# Final Decision

**File number(s):** PUD 2020-02, SUB 2020-03, & ZC 2020-02 Related to ANX 2020-03

**Project name:** Dove Landing

**Date of decision:** May 10, 2021

Exhibit PUD-3c: Sidewalks (blue: min 8 ft wide)

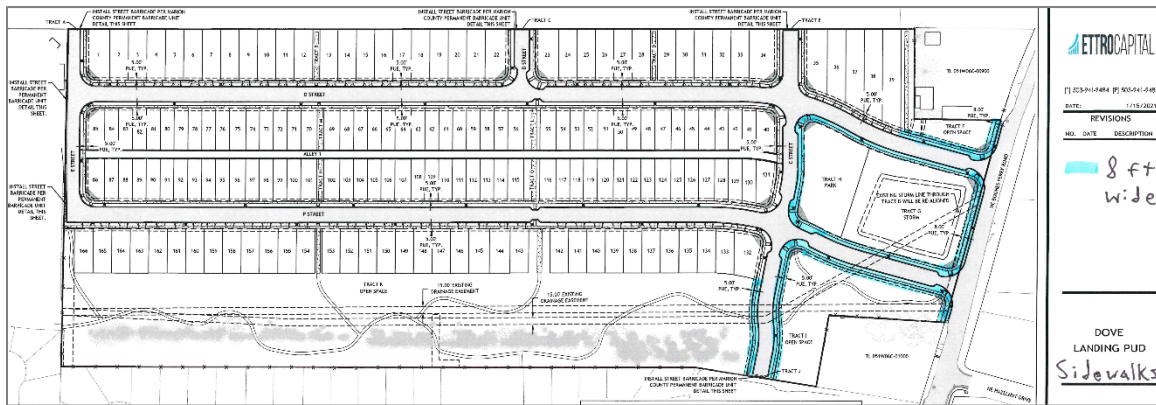
- a. BFR: Per WDO Fig. 3.01C except that planter strip shall be min 6½ ft wide inc. curb width.
- b. Planter strip remainder: Remaining ground not occupied by trees shall be planted with lawn grass.
- c. Sidewalks: Min 6 ft wide except wider as Exhibit PUD-3c supersedes. The BFR sidewalk dead-end(s) and “P” Street west dead-end shall have ADA-compliant transitions spanning between sidewalk and road shoulder. If PW were to direct during CEP review that the road crossing of the culvert have curb-tight sidewalk, min width shall be 8 ft.

Exhibit PUD-3e: Street Tree Min No. (green: equal to 1 tree per 30 ft of block frontage)

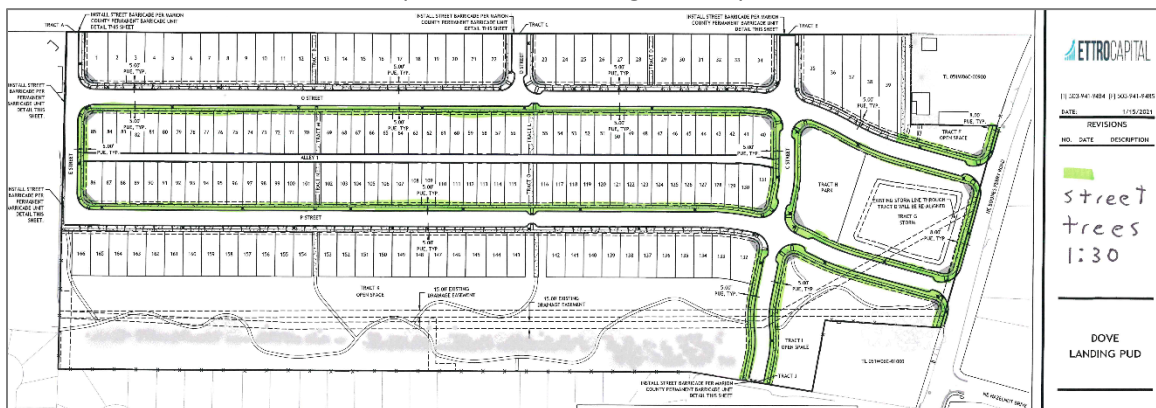
- d. Overlap: The extra width of planter strip and sidewalk shall either (1) overlap outside ROW into streetside PUE and where applicable Tracts I & K or (2) come with additional ROW to accommodate them. Wider sidewalks shall not narrow planter strips.
- e. Street trees: Min numbers equal to block frontage ratios per Exhibit PUD-3e.

Exhibit PUD-3g: Patterned Poured Concrete Crosswalks (symbolized in blue)

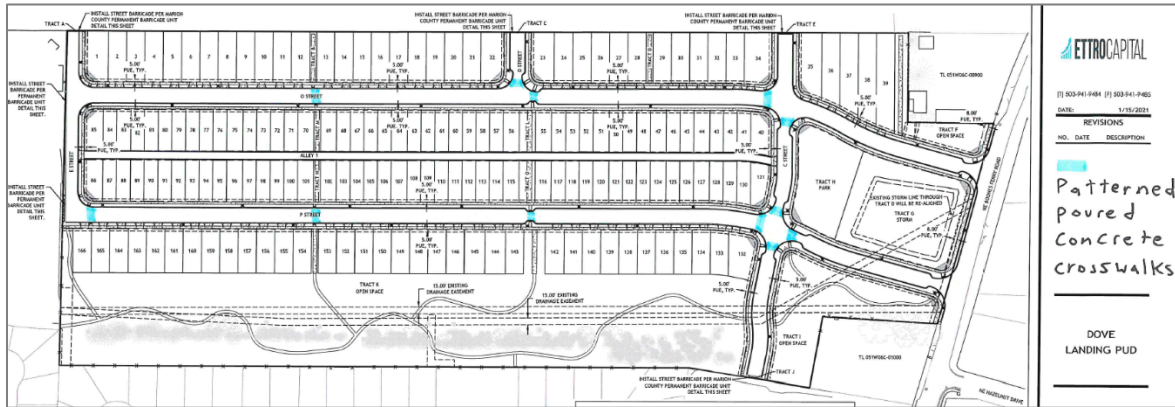
- (1) Bulb-outs / curb extensions: This condition approves them as land use review Sheet 5 illustrates, except the four along BFR. PW is prohibited post-approval from later eliminating or shrinking the remaining ones as to virtually eliminate them during CEP review and construction. The developer shall submit a fire truck turn radius plan confirming that the extensions are already designed for such if and when PW requests during CEP review.
- (2) Crosswalks / pedestrian crossings along intersection legs per Exhibit PUD-3g shall be patterned poured concrete each min 8 ft wide.

Exhibit PUD-6: Tracts to Dedicate to City (outlined in green)

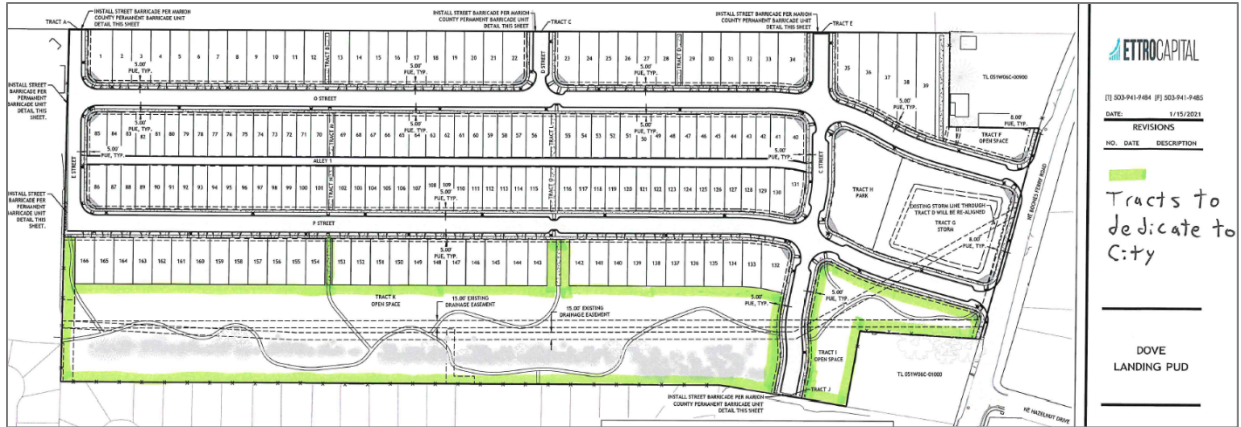
PUD-6. Public parkland: The developer shall dedicate Tracts I & K to the City. Refer to Attachment 203 for required improvements.

*Exhibit 205A1 Marion County Assessor's Office aerial view of subject property east area at BFR*

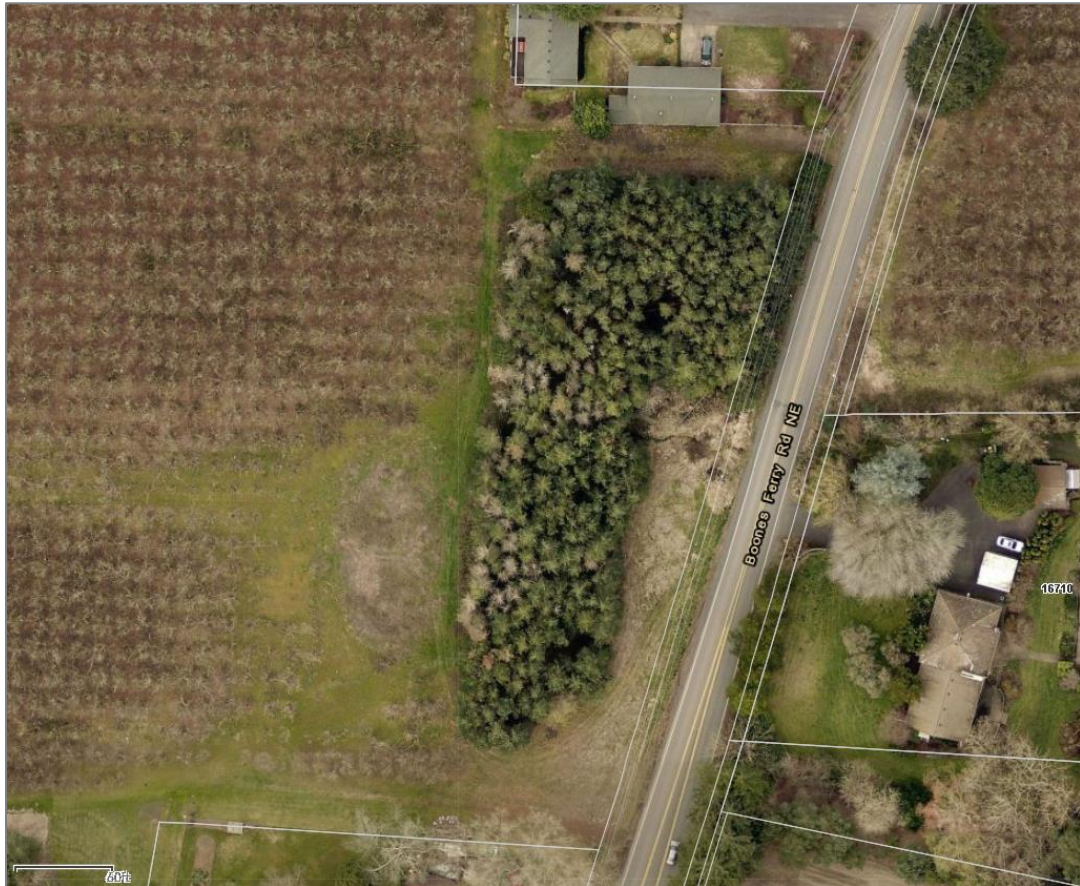
- (a) Objective: To preserve most of the trees within the small forest across BFR, "O", & "P" ROWs and Tracts F, G, & I, with focus on Tracts F & G.
